Office Action Summary

10/673,398

SONG, SI-HYUN

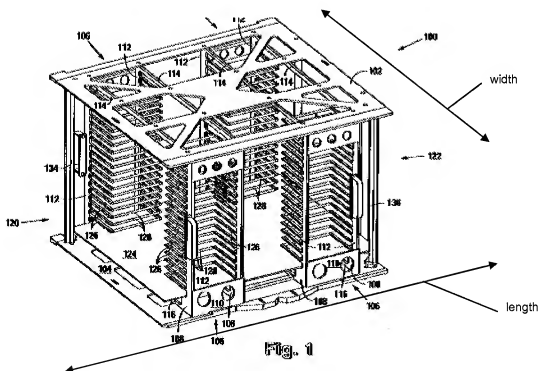
- a frame 108 having a length greater than a width as well as a height, wherein a length and width of a frame correspond to a length of width of inserted mother substrates, respectively (see FIG. 1 reproduced below);
- a first support members 126 protruding from a first side of a frame and second support members 126 protruding from a second opposing side of a frame;
- a robot arm (C2/L7-11);
- first supporting bars 128 connected to first support members and second supporting bars 128 connected to second support members, wherein supporting bars are disposed a distance from a frame,
- wherein first and second supporting bars 128 contact and support a lower surface of an inserted mother substrates along first and second parallel sides

of an inserted mother substrates at opposing parallel regions of a first lower surface, wherein first supporting bars are configured slightly spaced from each other and second supporting bars are slightly spaced (e.g. in a vertical sense) from each other, so that first and second supporting bars are in contact with substantially a whole width of the of first and second parallel sides of inserted mother substrates to uniformly distribute a load to the patterned spacers in substantially the whole width of the first and second parallel sides of the inserted mother substrates across the substrate.

Babbs does not disclose rectangular supporting bars connecting two support members.
